SILVERADO RANCH

MASTER DEVELOPMENT DRAINAGE PLAN

D1

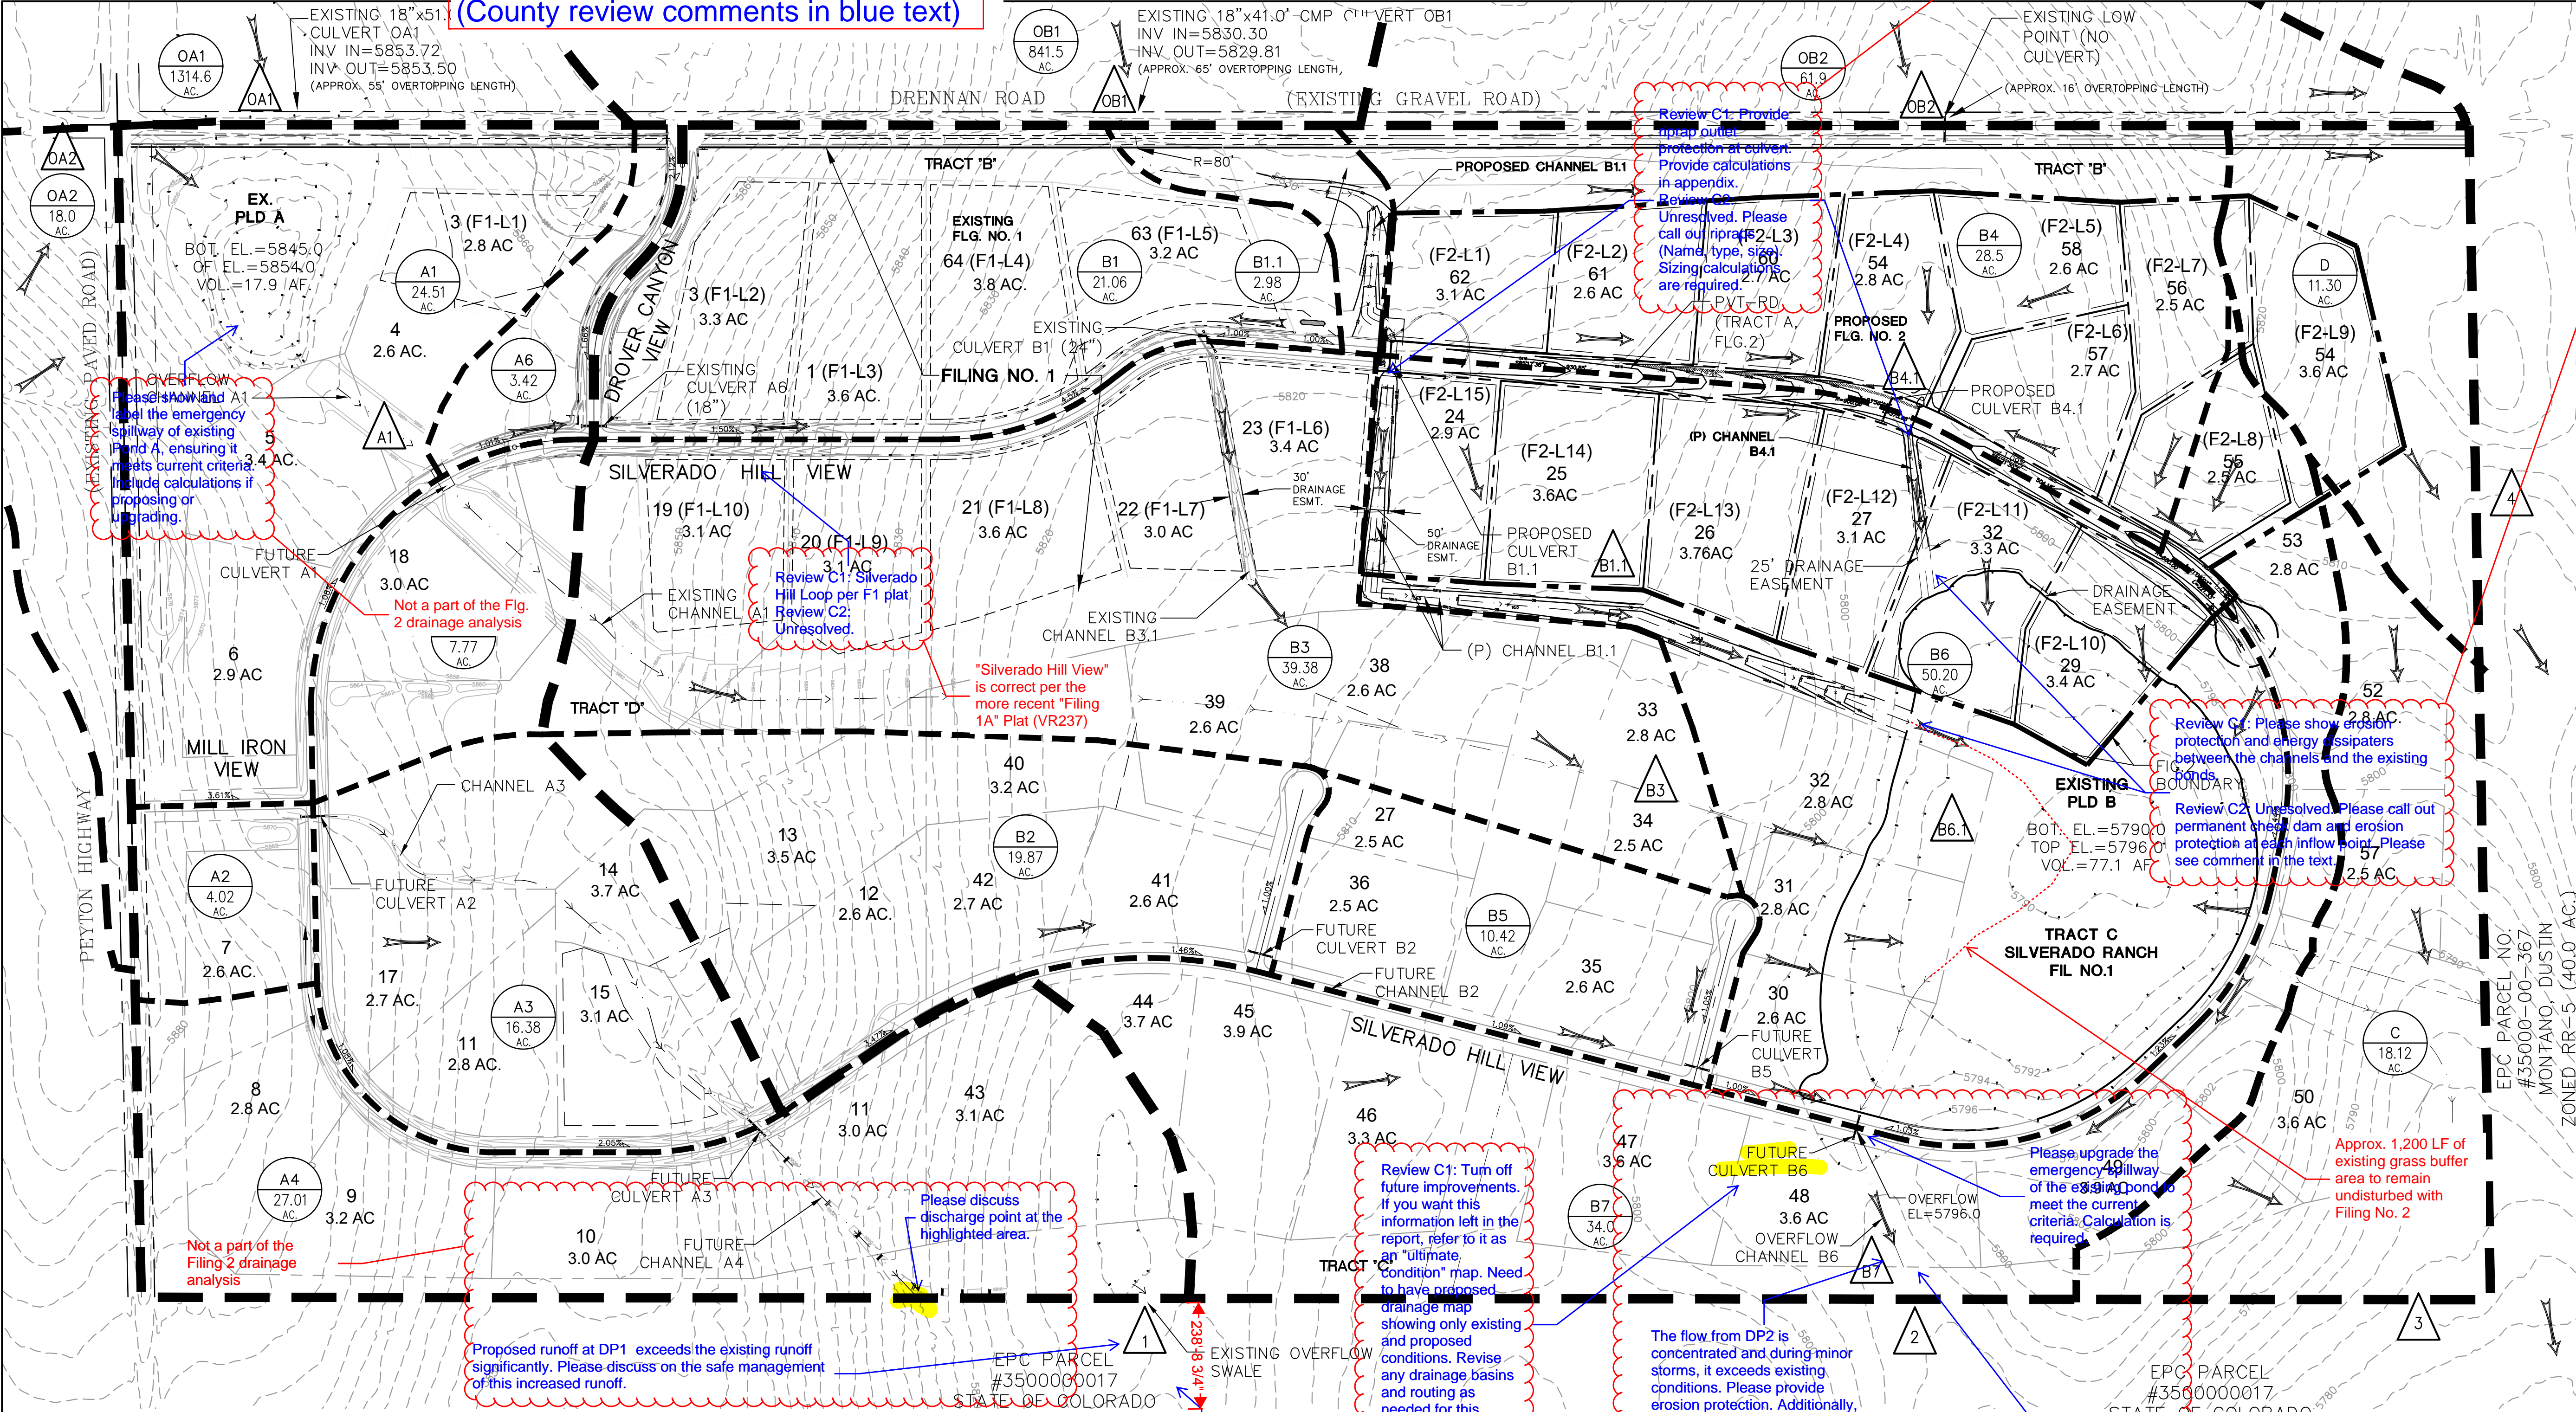
Proposed runoff at DP1 exceeds the existing runoff significantly. Please discuss on the safe management of this increased runoff.

Please display the off-site contour 50-100 feet beyond the boundary or drainage basin delineation line to illustrate how the runoff diverges from the site

Review C1: Turn off future improvements. If you want this information left in the report, refer to it as an "ultimate condition" map. Need to have proposed drainage map showing only existing and proposed conditions. Revise any drainage basins and routing as needed for this condition.

Review C2: Unresolved.

Review C1: Include all basins and design points on the hydrology calculation spreadsheets which are shown on drainage maps
Review C2: Unresolved.

OVERFLOW
Please show and label the emergency spillway of existing Pond A, ensuring it meets current criteria. Include calculations if proposing or upgrading.

Review C1: Please show erosion protection and energy dissipaters between the channels and the existing ponds
Review C2: Unresolved. Please call out permanent check dam and erosion protection at each inflow point. Please see comment in the text.

Review C2: Unresolved. Please call out permanent check dam and erosion protection at each inflow point. Please see comment in the text.

Please upgrade the emergency spillway of the existing pond to meet the current criteria. Calculation is required.

The flow from DP2 is concentrated and during minor storms, it exceeds existing conditions. Please provide erosion protection. Additionally, how can this concentrated flow downstream be mitigated?

Review C1: List all storm facilities/structures as public or private

Review C2: Unresolved.

Review C1: Easement lines missing. Please turn on
Review C2: Unresolved.

Added permanent Rock Check Dam and Riprap Apron call outs at each inflow point

Sh. D1.2: Filing 2 Developed Drainage Plan was previously added in response to this comment: Title for this sheet has been updated to "Ultimate Conditions; For Reference Only"

All basins and design points have been provided

Not a part of the Fig. 2 drainage analysis

These comments will be addressed with the applicable future phase; this area will not be disturbed during Filing No. 2

This comment was addressed by adding a note at bottom of Sh. D1.2 stating "All Proposed Storm Facilities Are Private (HOA-Maintained)"
